MEMORANDUM

Date:	September 10, 2021	Project #: 23021.35
To:	James Feldmann	
From:	Kim Marshall, Barney and Worth Camilla Dartnell, PE, and Phill Worth, Kittelson and Associates, Inc.	
Project:	Highway OR 99W South Corvallis Facility Plan	
Subject:	OR 99W South Corvallis Open House 2 Summary

Interchange Area

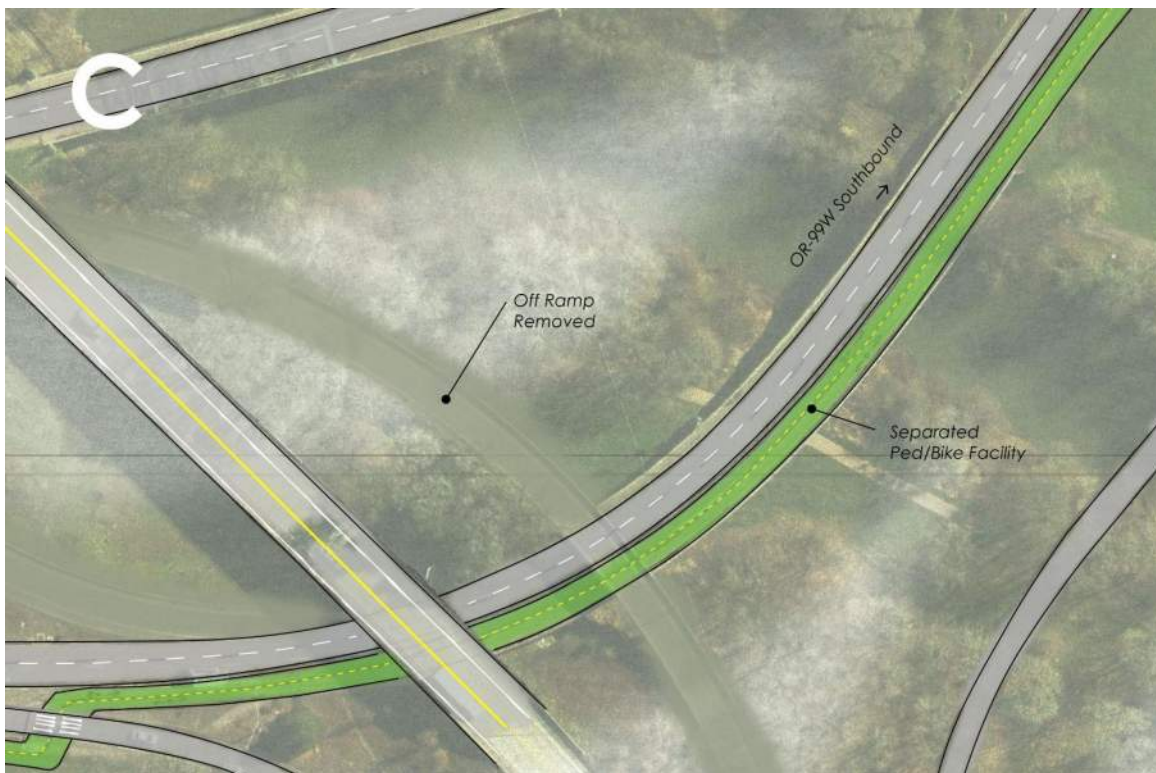
"The roundabout is brilliant! Please keep it."

"I think the roundabout is the most effective solution because it would really slow down traffic and signal that the areas is actively used by pedestrians and cyclists."

"Very concerned about how a bicycle navigates the circle - with automotive traffic or by having to wait for someone to stop for them at every crossing?"

"I'm a little uncertain how pedestrians will interface with the roundabout, and will want solutions for how they can cross 99 safely."

"I like the idea of the roundabout, but this will be a very complex roundabout that could be very confusing for motorists not familiar with it."

"Proposed off ramp from Hwy 34 directly into the new traffic circle could cram a lot of traffic into there. The new off ramp configuration is my least favorite part of this"

"My only concern is the proposed new offramp eastbound to southbound ramp connection from US-20/OR-34. The addition of this offramp is a great idea, but why remove the existing off-ramp that feeds into downtown? It seems that 90% of the traffic on that offramp are headed northbound, so funneling all that traffic into Southtown will unnecessarily increase the traffic burden in a part of town that prides itself on being quiet and 'out of the way'."

"With the separated bike/pedestrian path southbound, I think that the current exit from 34 going west could be left in place, reducing congestion on southbound 3rd street."

"Can the bike/ped lane cross under the westbound ramp rather than have a surface crossing?"

"Crystal Lake to Avery is a major intersection with a lot of bicycle and pedestrian traffic (connecting folks to the 20/34 Westbound bike system particularly). This might be crazy, but always thought this would be a really great spot for a pedestrian bridge (bridging from Crystal Lake to Avery Dr)"

SE Chapman Place to Urban Growth Boundary

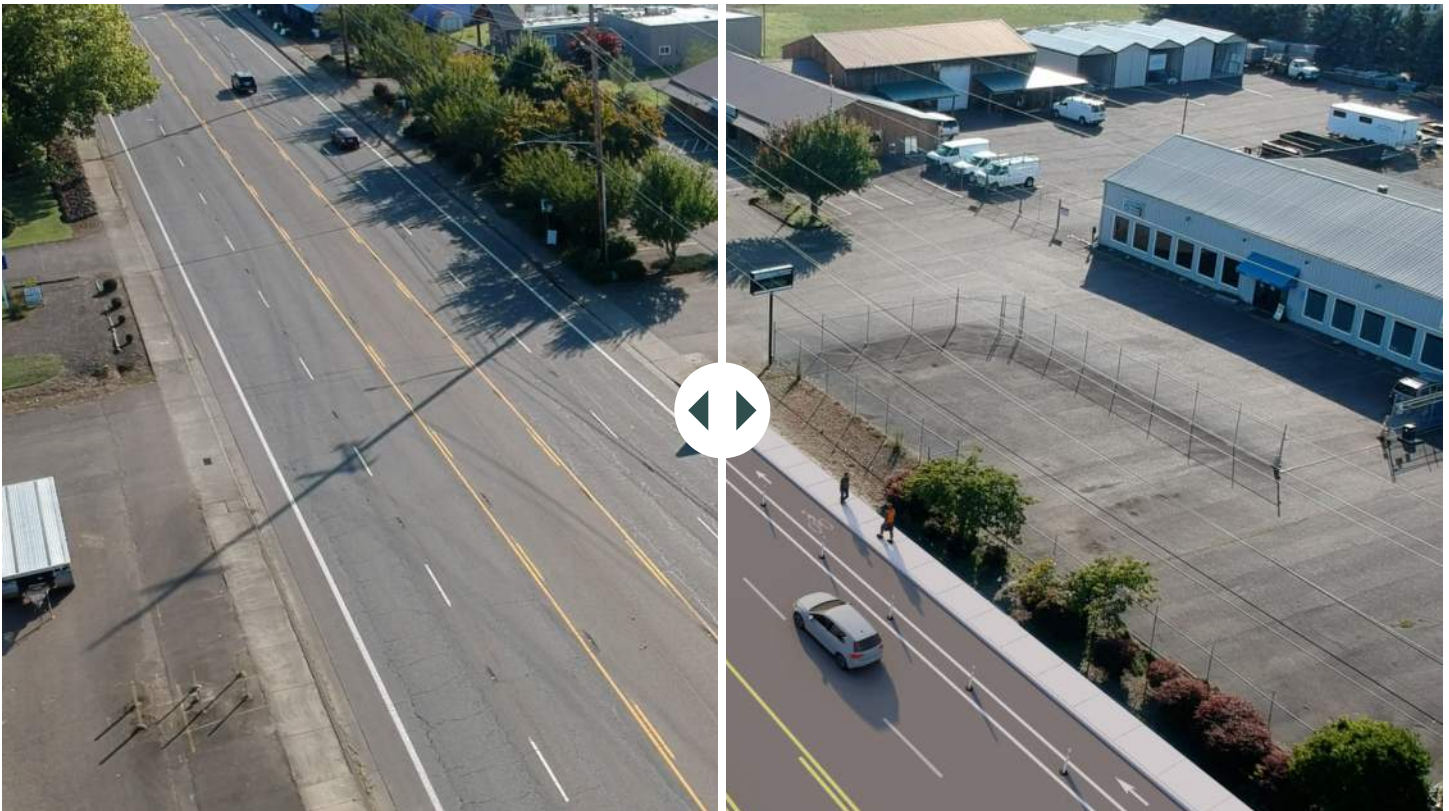
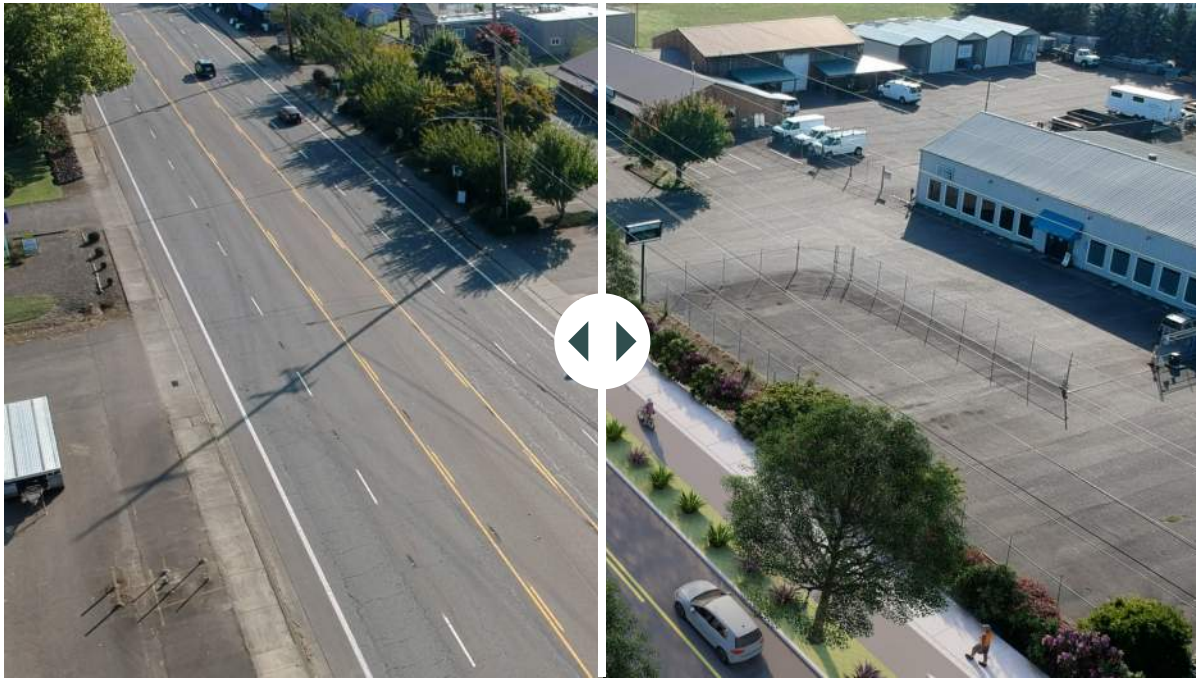
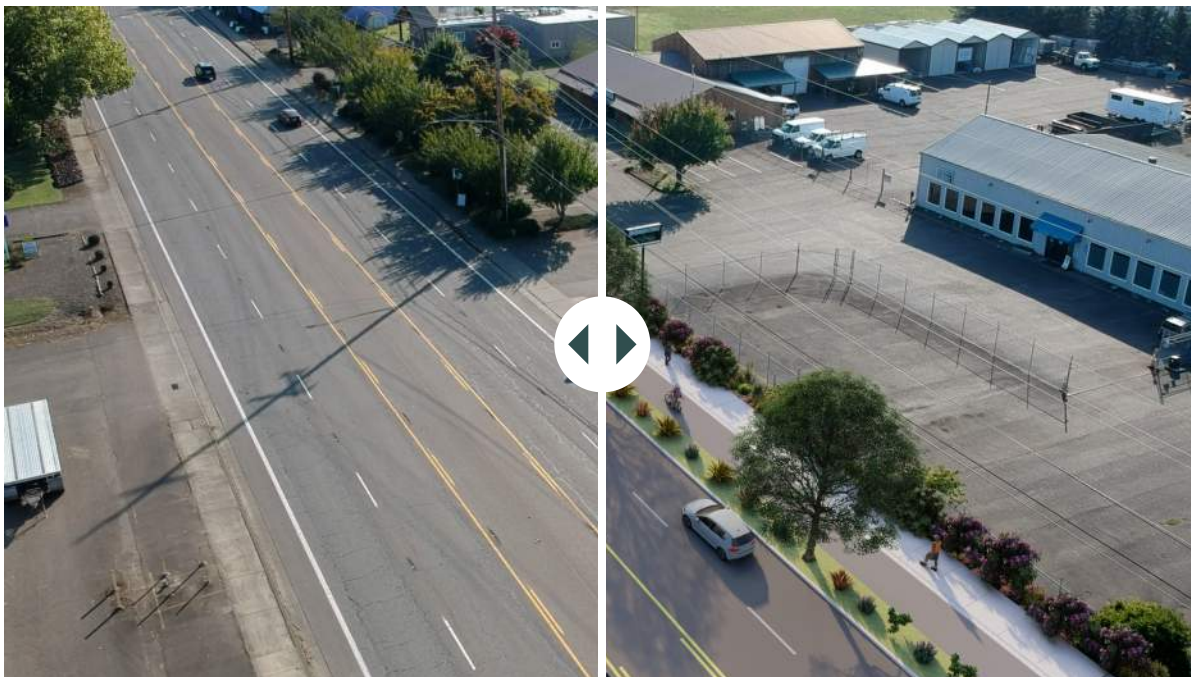
"Absolutely. I drive thru this area regularly and would not complain about increased congestion and slower speeds!"

"You BETCHA - I have to drive through there daily and I'm very willing to drive slower to make my neighborhood nicer. I'd rather drive slow through a nice place than fast through what we have now."

"We do not want highway traffic passing through our streets to circumvent the highway."

"Installing parallel sidestreet networks would not be a solution to the issue of too much traffic, because it would divert Hwy 99 traffic into the residential neighborhoods which is not safer than keeping the traffic on the highway, and would create the potential for even more danger."

“Adding more traffic to even higher density residential zones seems like a bad idea for residents’ quality of life.”

“I have distinct preference for the “road diet” plan (3-lanes). It is the one which will result in peds/bikes feeling comfortable moving around in the corridor.”

“Hilyard St and 30th is a good example of the type of planted medians I’d like to see on OR 99W.”

“In the meantime, I would strongly prefer a vertical solution to buffer the bike lane from the other lanes of traffic.”
